HIGHLAND CITY DEVELOPMENT ADMINISTRATION BOARD AGENDA Wednesday, March 11, 2026

DEVELOPMENT ADMINISTRATION BOARD AGENDA REPORT ITEM #2

DATE: March 11, 2026
TO: Development Administration Board
FROM: Rob Patterson, City Attorney / Planning & Zoning Administrator
SUBJECT: Final Plat Approval: Ridgeview Pod B Plat O
TYPE: LAND USE (ADMINISTRATIVE)

RIDGEVIEW POD B PLAT O
HIGHLAND CITY, UT
COVER SHEET

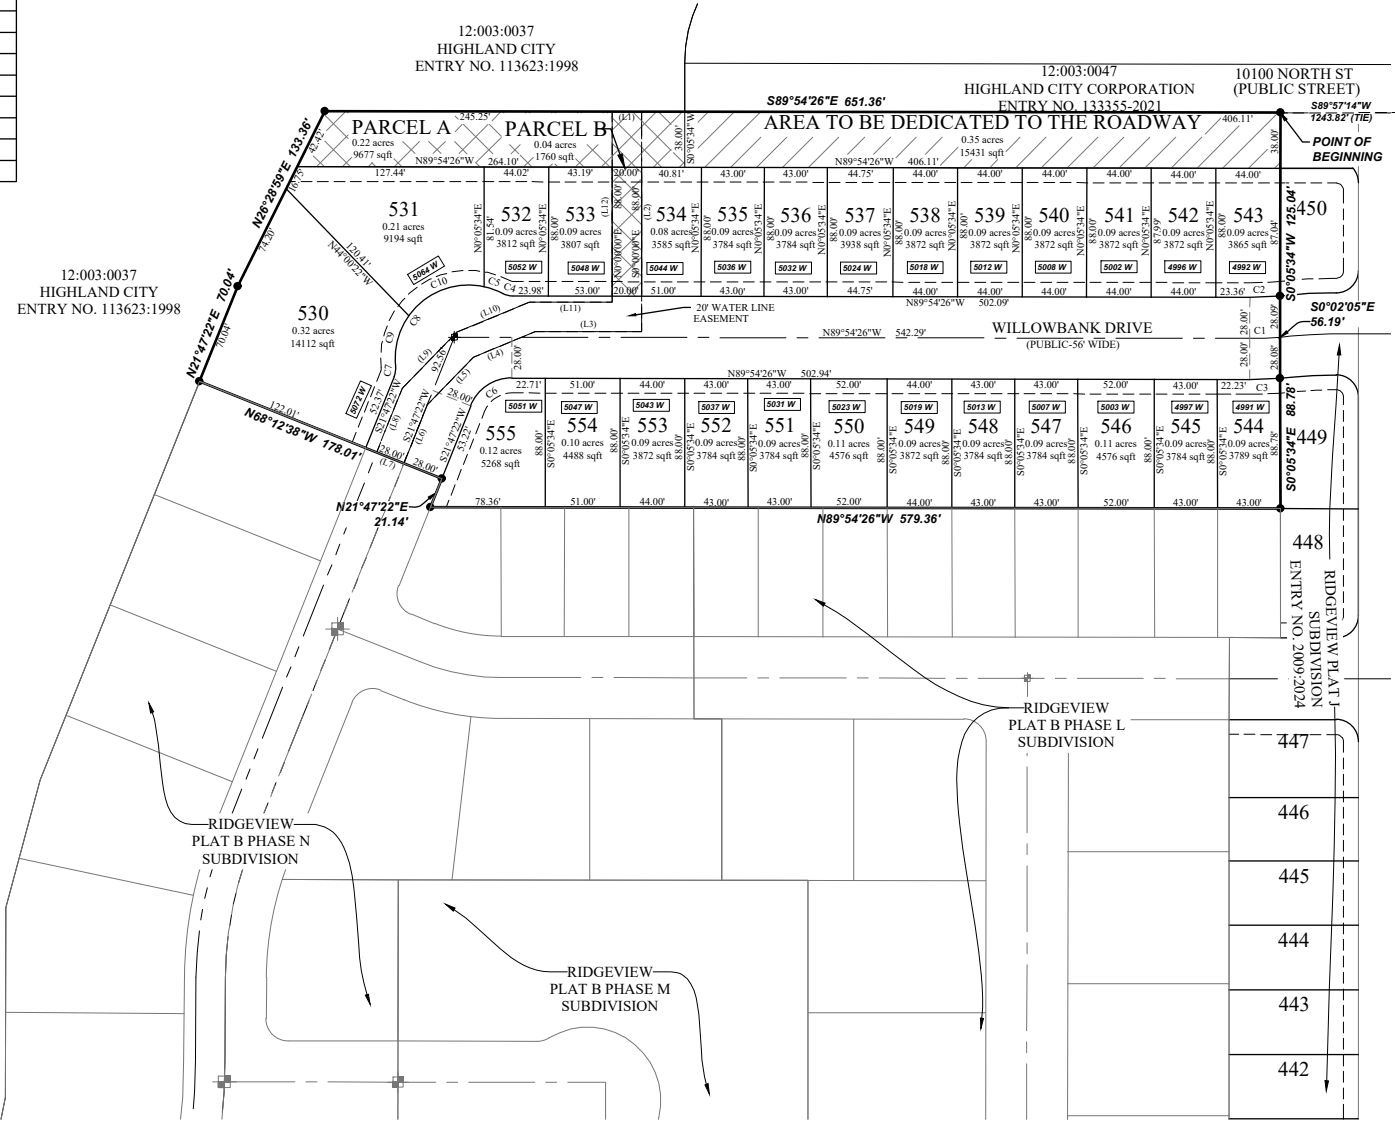
1. Plat must receive final review from JUB and Utah County for conformance and recordability.
2. Surrounding plats are Pod B, not Plat B, and Plat N/M/L/J not Phase N/M/L/J.
3. Parcel A shows a line with bearing and distance north of lot 534. Justify or, if not necessary, remove prior to printing.
4. Describe Parcel B in note 10 as subject to utility easement.

Scale: 1"=30'
 Date: 02/25/26
 Sheet: C3

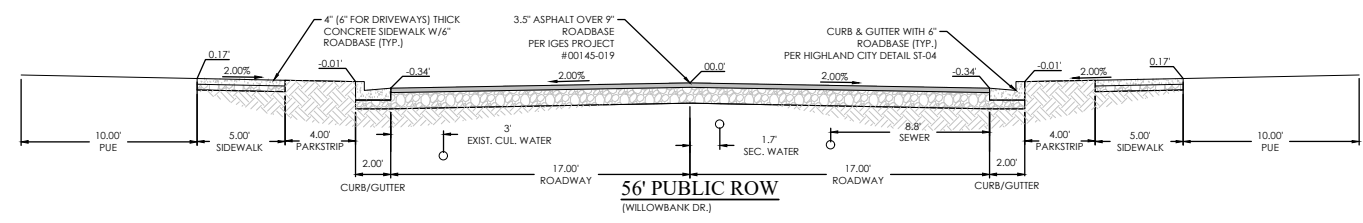
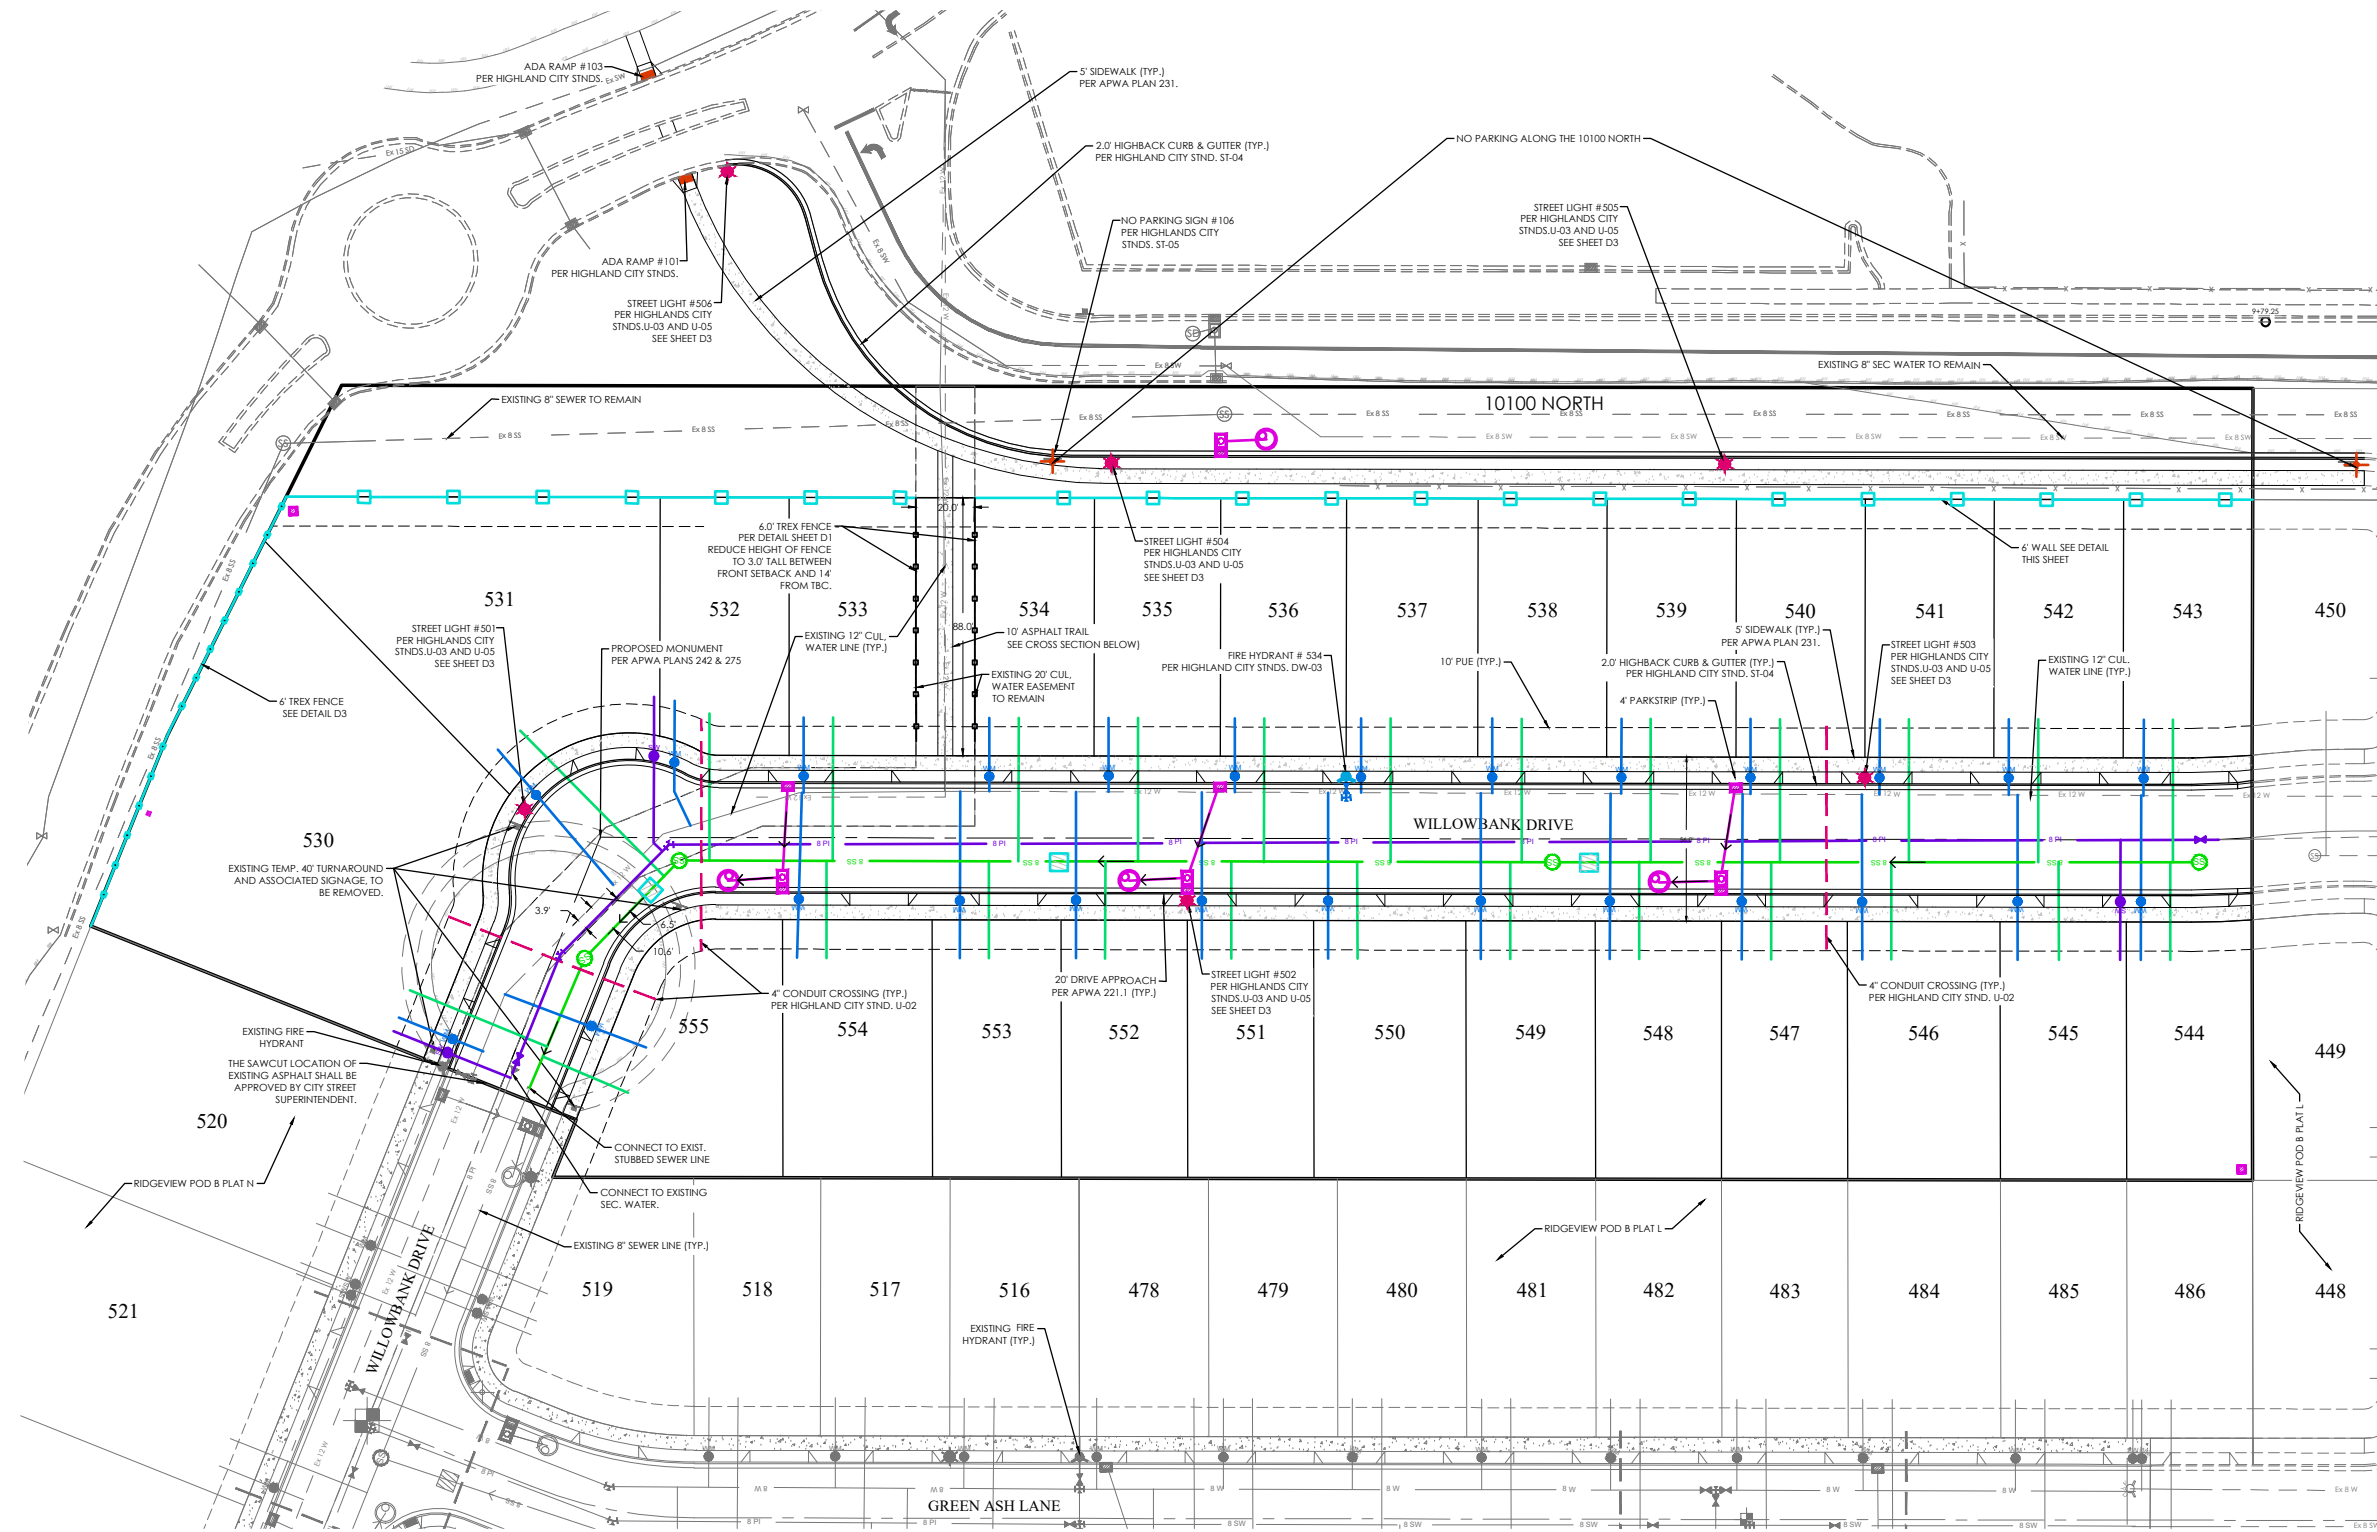
5. Move PI service to north side of valve for lot 530.
6. Callout for trail references a cross section that was not provided. Provide cross section for trail/Parcel B.
7. Show and label PI service for lots 532 to 543, even if it is on the adjacent lot 450.
8. Label PI service for lots 544 to 554.
9. Show proposed roadway monument on this sheet.
